DEPARTMENT OF PUBLIC WORKS

VOL. 1: STANDARD DRAWINGS

Addendum No. 10
Published: January 2025

ADDENDUM No. 10
TO THE
CITY OF FRESNO
PUBLIC WORKS STANDARD DRAWINGS AND SPECIFICATIONS
ADOPTED MARCH 4, 1970, BY RESOLUTION NO. 70-36

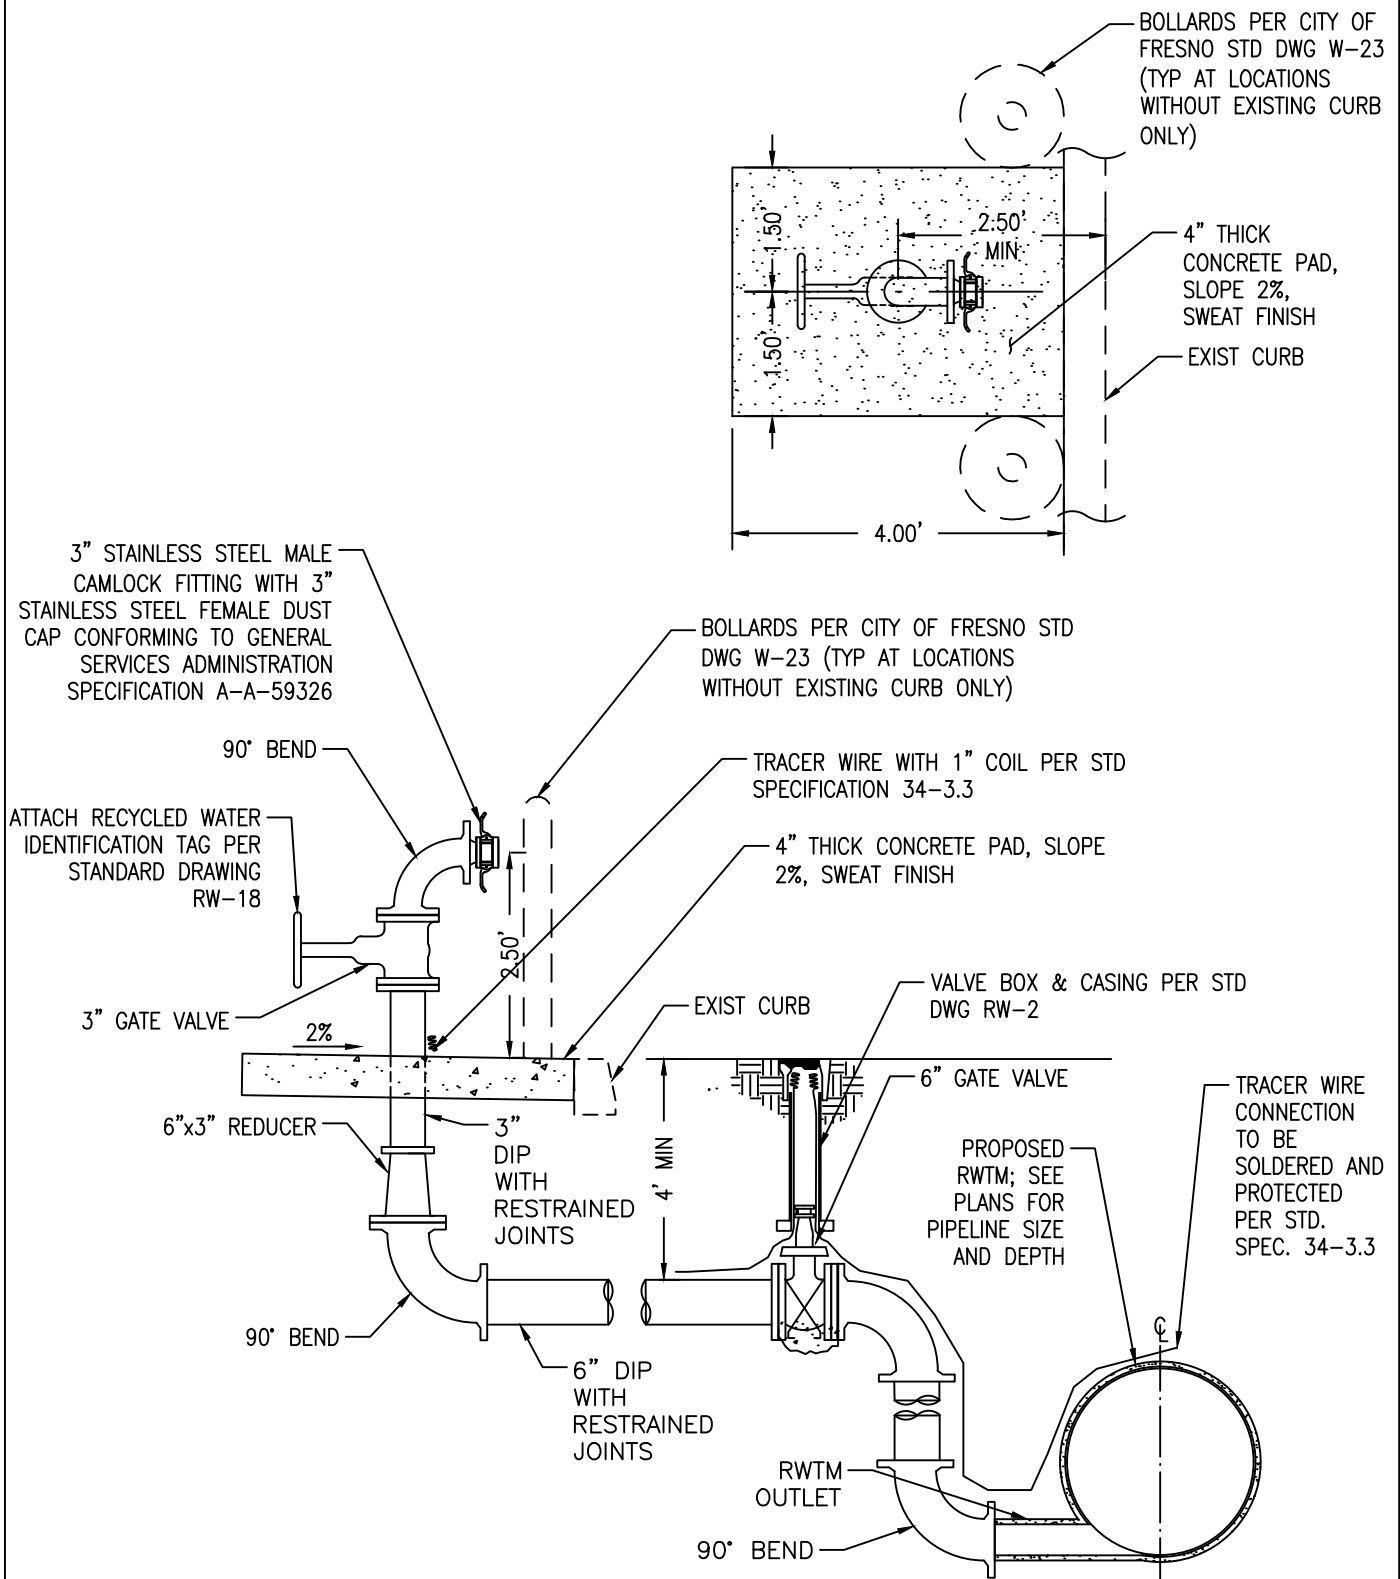
RW-10	1. Drawing title: "RECYCLED WATER 4" AIR RELEASE/VACUUM BREAKER STATION" Revised to read, "RECYCLED WATER 4" AIR RELEASE/VACUUM BREAKER ASSEMBLY" 2. Callout: "AIR/VAC ENCLOSURE (To be specified)" Revised to read, "AIR/VAC ENCLOSURE PER STANDARD DRAWING RW-26" 3. Callout, "TRACER WIRE WITH 1' COIL, PER STANDARD SPEC. 22-3.3" Revised to read: "TRACER WIRE WITH 1' COIL PER STANDARD SPEC. 34-3.3" 4. Tracer wire relocated to inside the riser barrel.
RW-11	1. Standard is no longer used.
RW-12	1. Revised dimensions on "RECYCLED WATER CROSSING SEWER MAINS" detail.
RW-24	1. Note 6 renumbered to Note 7 2. Note 5 renumbered to Note 6 3. Added new Note 5: "SOLDERING PASTE MUST BE APPLIED TO THE LOOPS BEFORE HEAT IS APPLIED IF ROSIN CORE SOLDER IS NOT USED." 4. Note 6: "COVER ALL BARE COPPER WIRE WITH A WATERPROOF WRAP THAT IS APPROVED FOR UNDERGROUND CONNECTIONS. THE WRAP MUST EXTEND A MINIMUM OF TWO INCHES (2") BEYOND THE END OF THE STRIPPED WIRE." Revised to read, "COVER ALL BARE COPPER WIRE WITH A WATERPROOF WRAP THAT IS APPROVED FOR UNDERGROUND CONNECTIONS (3M DBR/Y-6 OR APPROVED EQUAL). THE WRAP MUST EXTEND A MINIMUM OF TWO INCHES (2") BEYOND THE END OF THE STRIPPED WIRE." 5. Note 7: "ALL WIRE MUST BE 12 GAUGE COPPER WIRE." Revised to read, "ALL WIRE MUST BE 10 GAUGE COPPER WIRE."
